STANDARDIZATION OF COMPONENTS
FOR
CD V-700, CD V-715, CD V-727

BY
THE VICTOREEN INSTRUMENT COMPANY
CLEVELAND, OHIO

III. Recommended Specification Changes

A. Changes in CD V-700 Specification dated November 1, 1959.

FIGURE 1

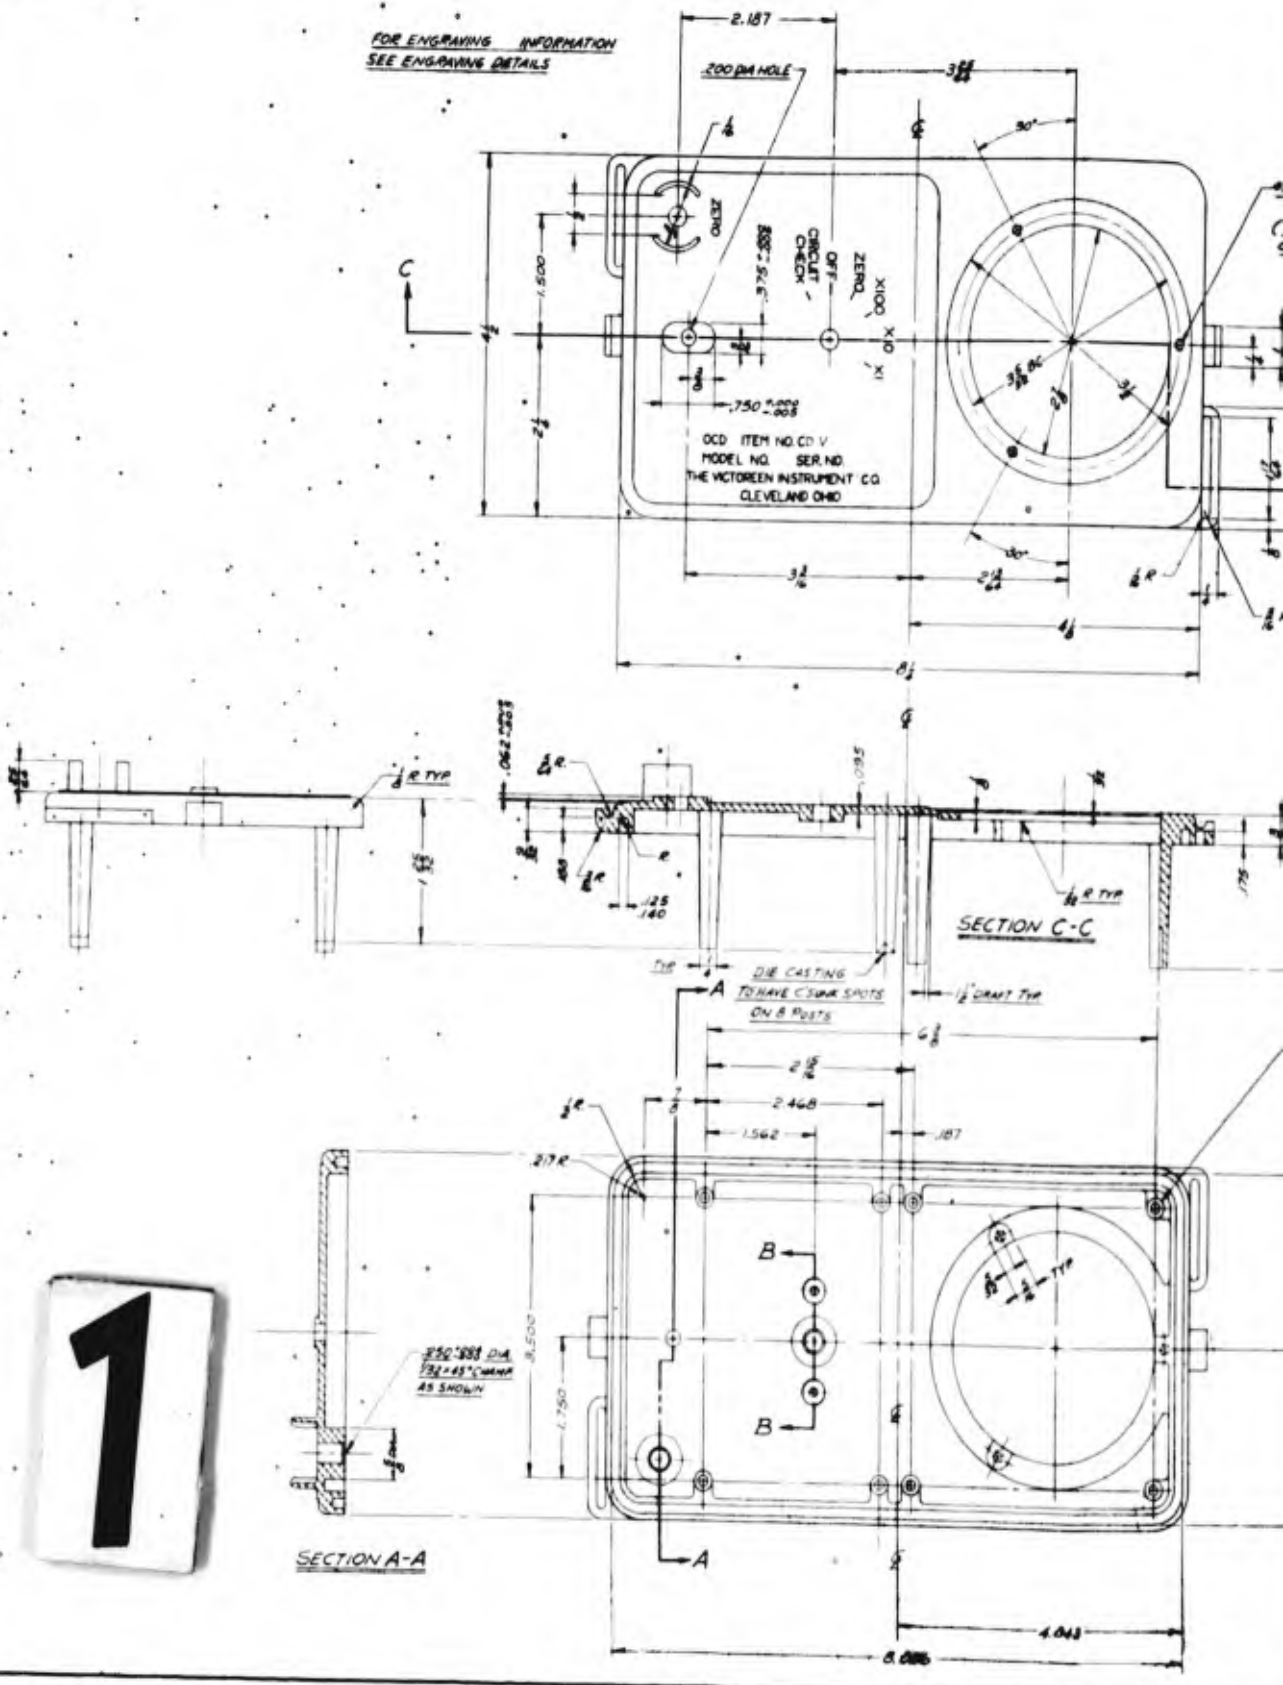
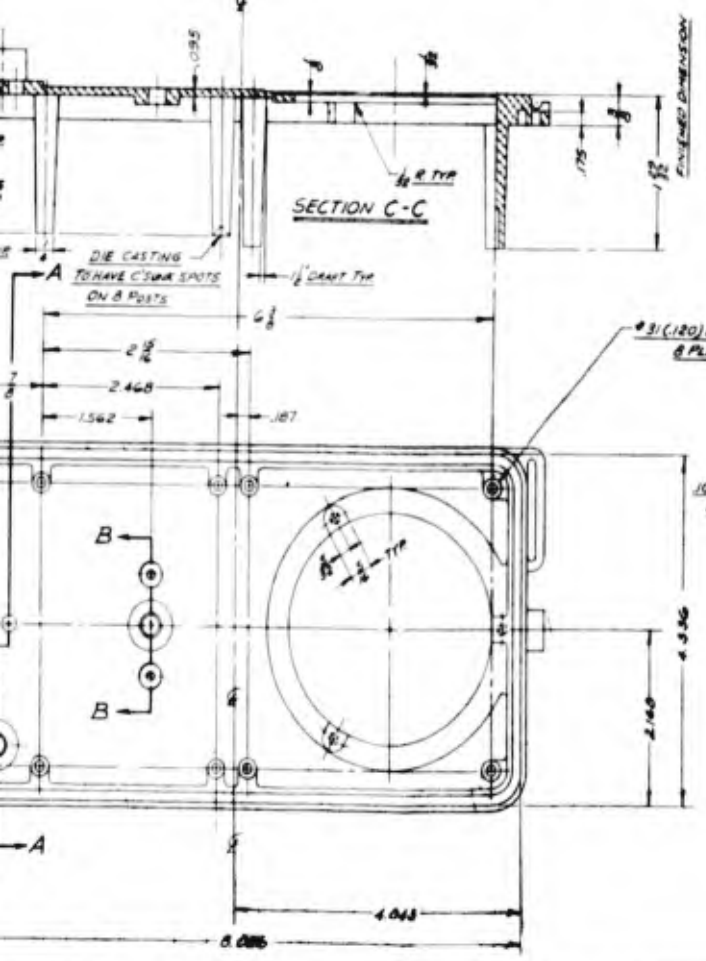
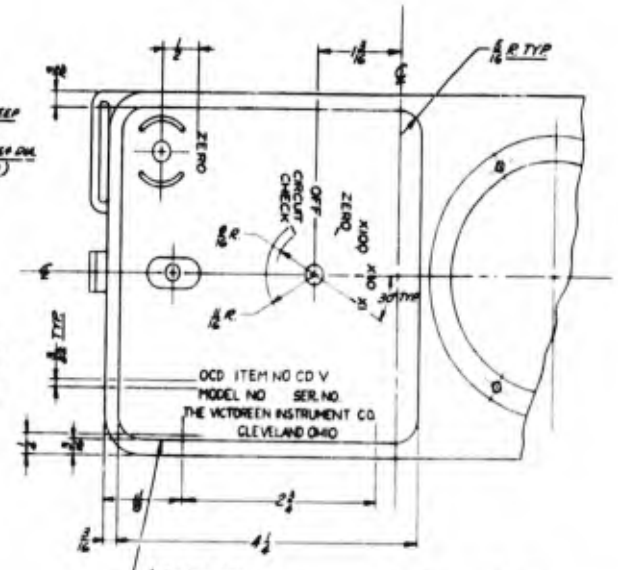
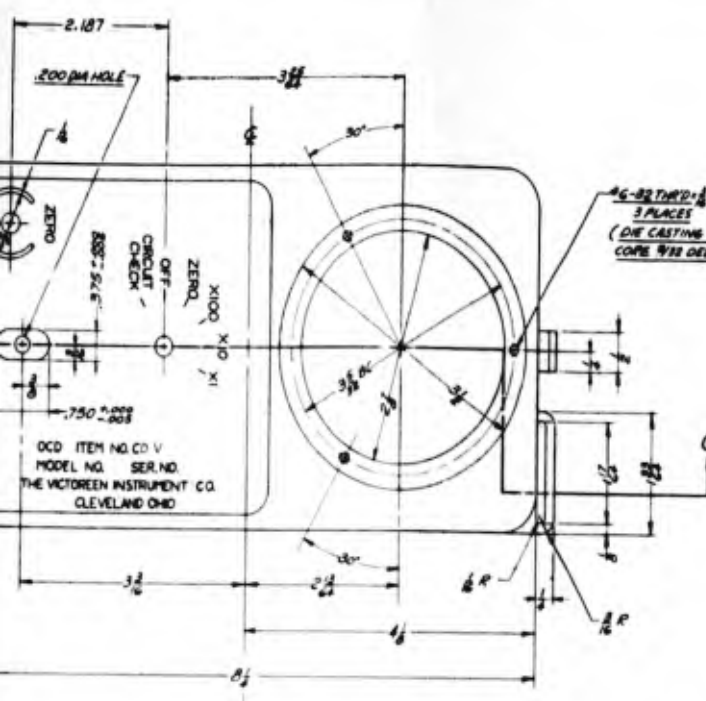
13. Attachment D. Replace page D-2 with drawing 815-103 (Figure 1 of this report). Replace page D-3 with drawing 700-214, battery box assembly, and details 700-209 and 700-210 (Figures 3, 4 and 5 of this report). Add as page D-6 the drawing 815-106, case bottom (Figure 2 of this report).

10. Attachment C. Substitute drawing 815-103 (Figure 1 of this report) for page

6. Attachment C-2. Replace with drawing 815-103 (Figure 1 of this report).

FIGURE 2

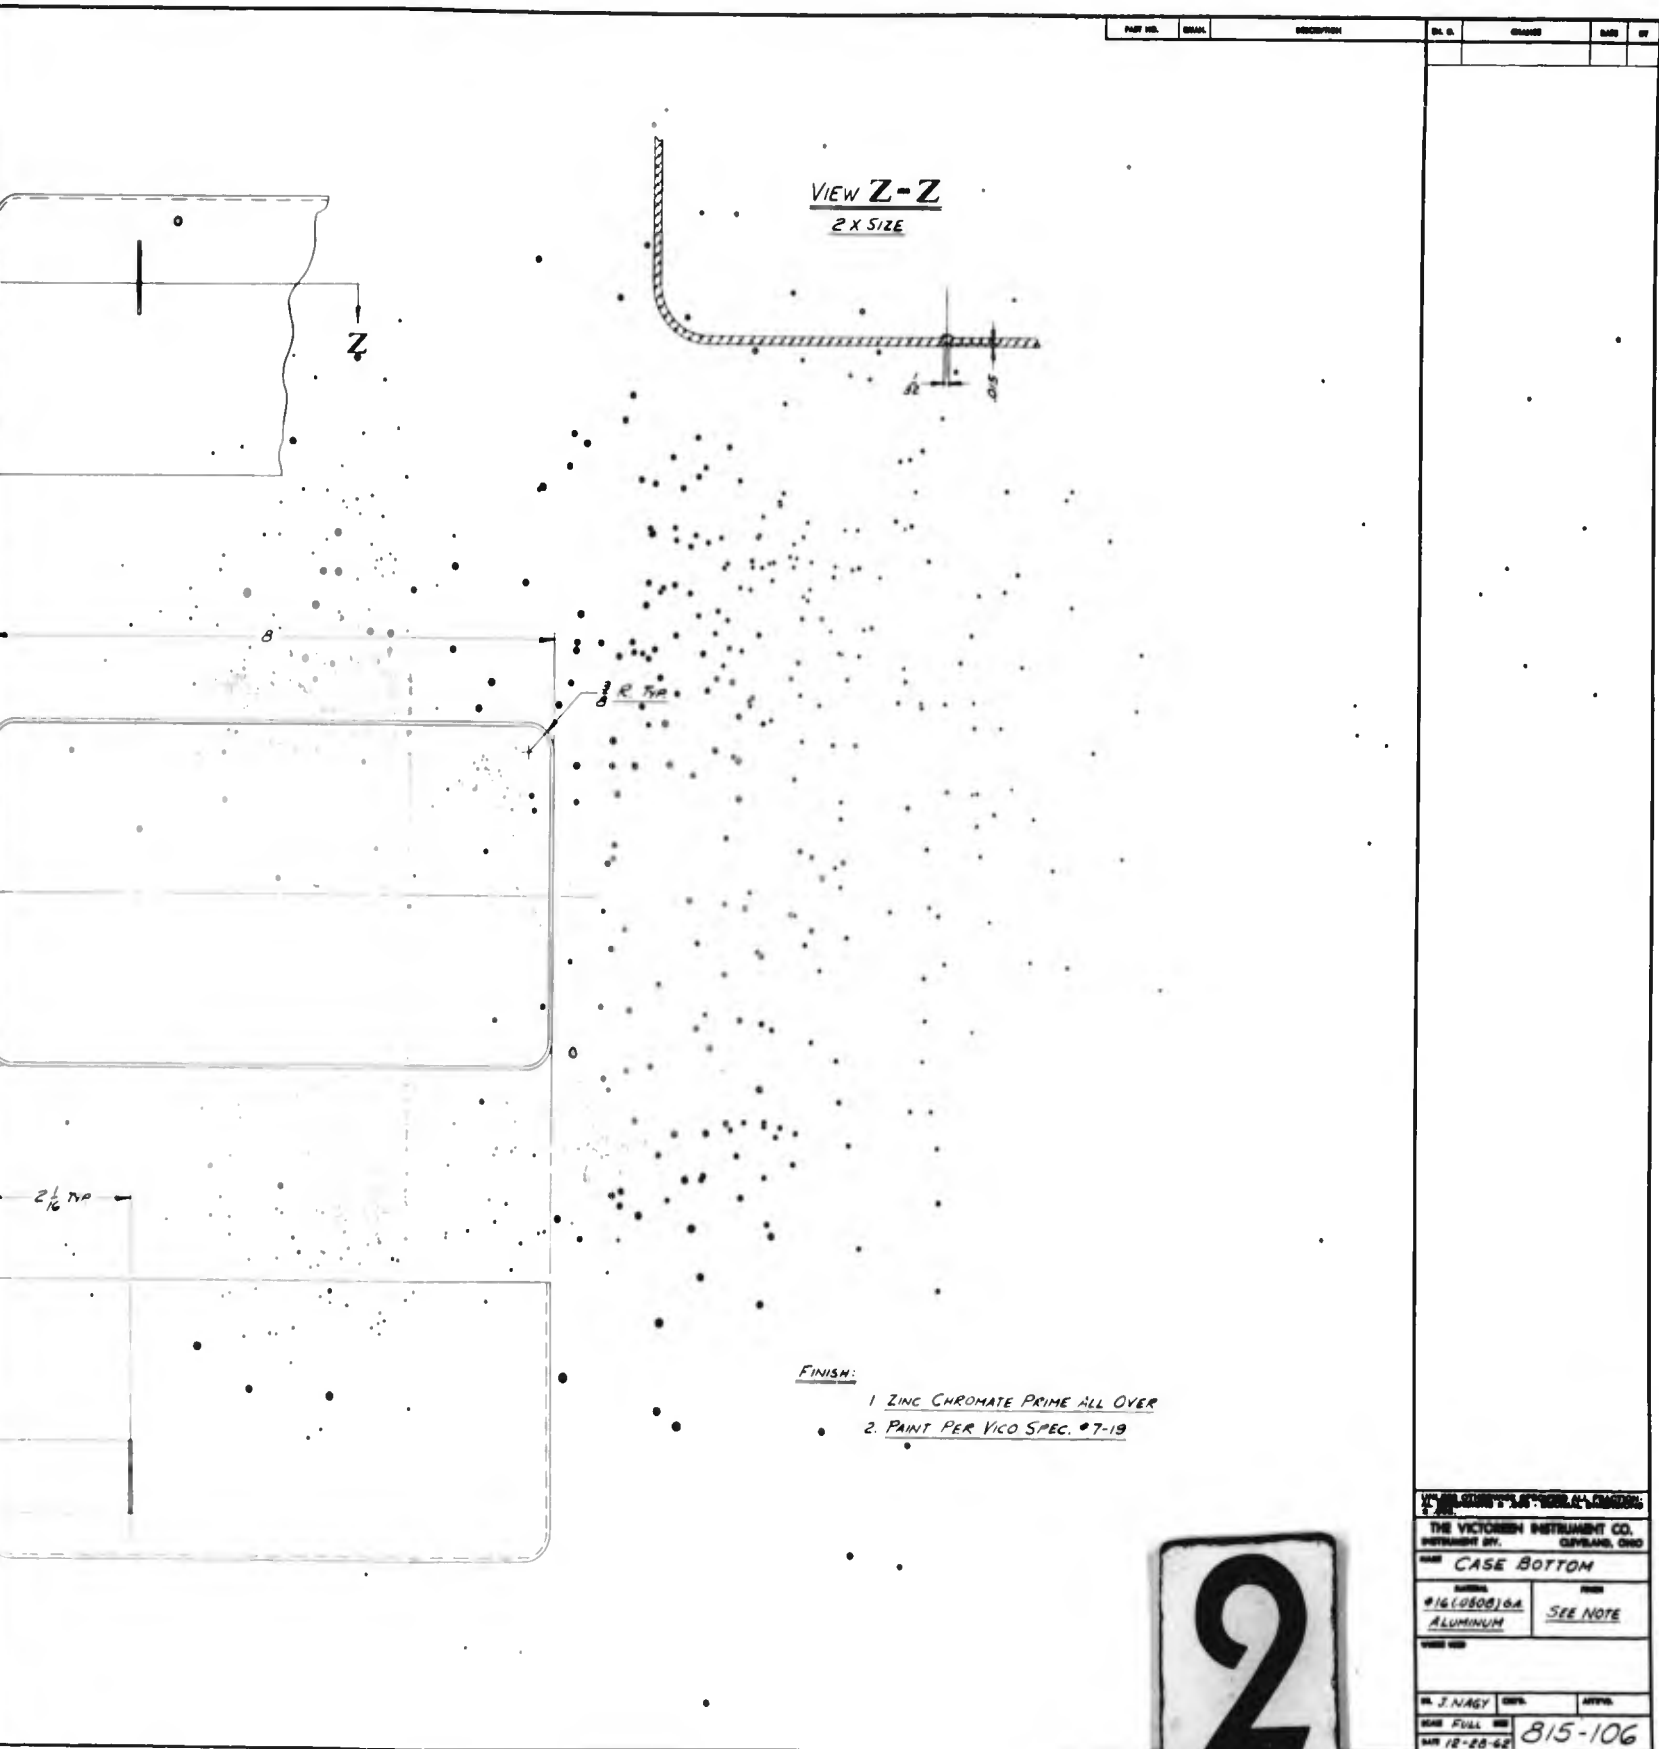
C-2. Add drawing 815-106, case bottom (Figure 2 of this report) as page C-3.

7. Attachment C. Add drawing 815-106 (Figure 2) as Attachment C-4.

Because of the above, the standardized case top may not be used as a replacement part for all existing instrument models. However, the case bottom shown in Figure 2 may be so used. This figure calls for an aluminum bottom, but a drawn steel version with a slight flange is entirely adequate from the gamma-ray absorption consideration discussed later, as long as the dimensions of Figure 2 are not violated. The use of steel has therefore not been eliminated from the proposed specification.

FIGURE 3

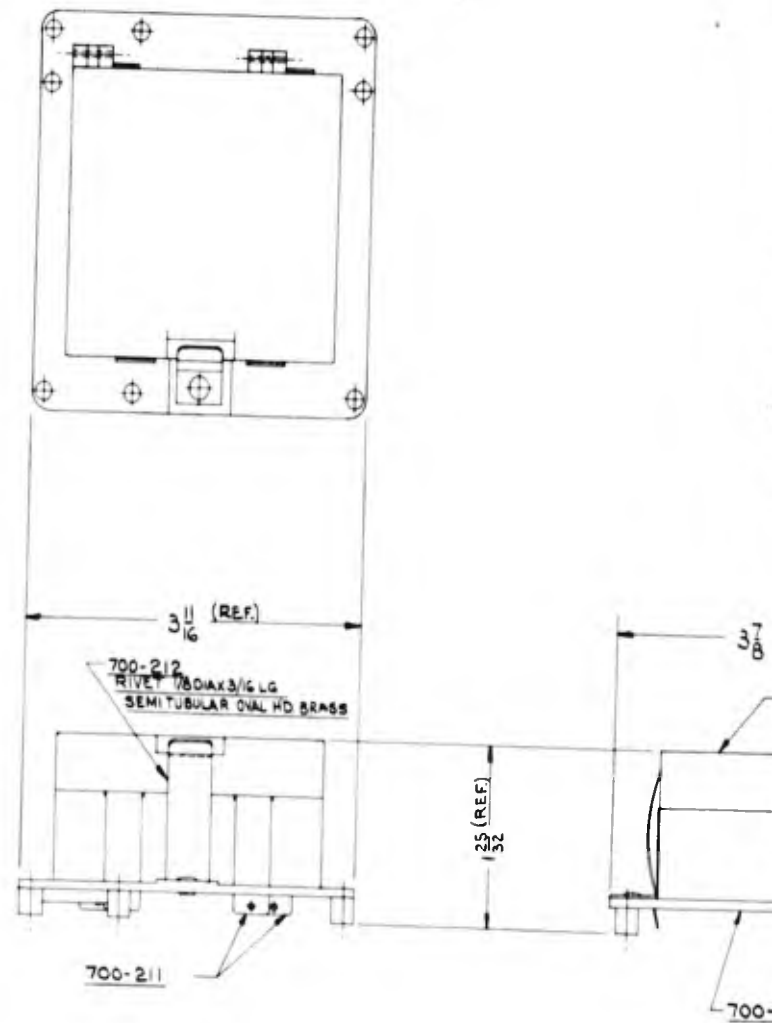
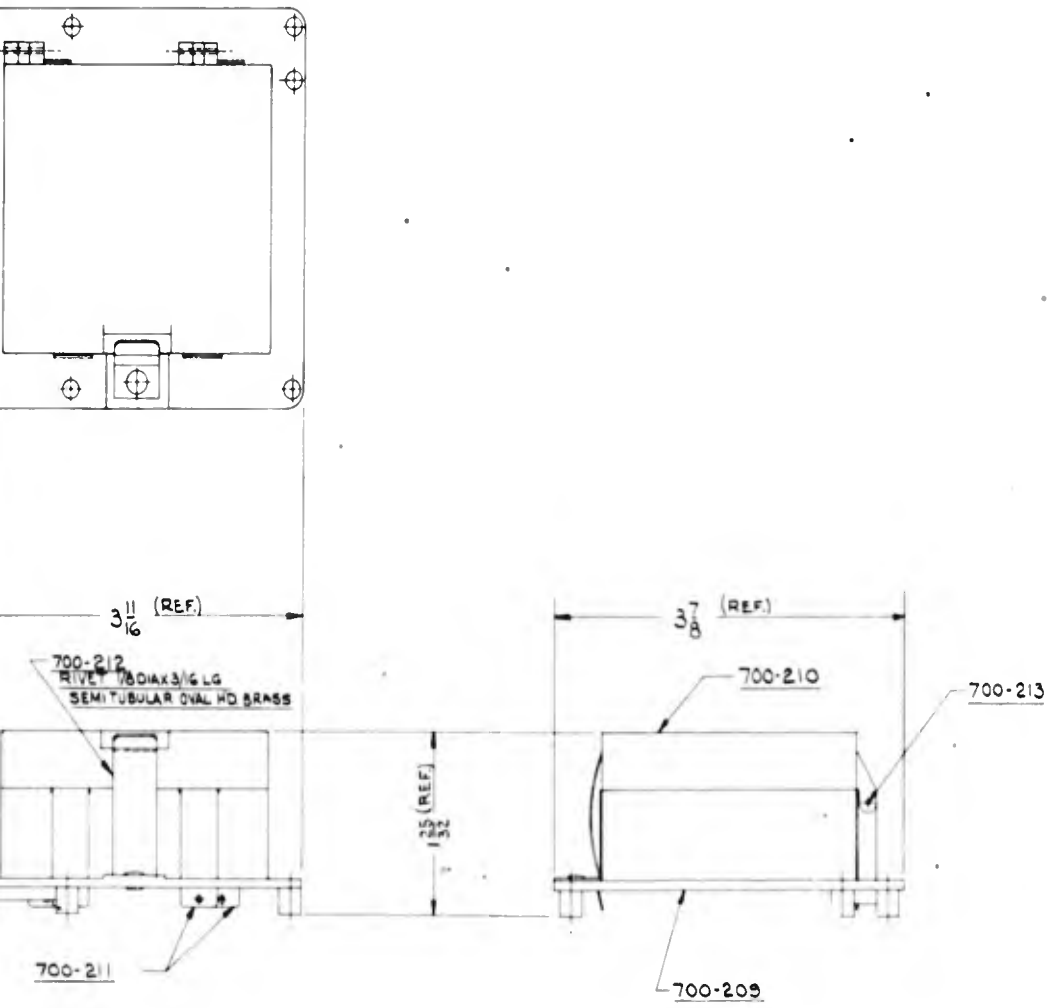
8. Attachment D-2. Replace battery box drawing with drawings 700-214, 700-209, 700-210, 815-100, 815-101, and 815-102 (Figures 3 thru 8 of this report).
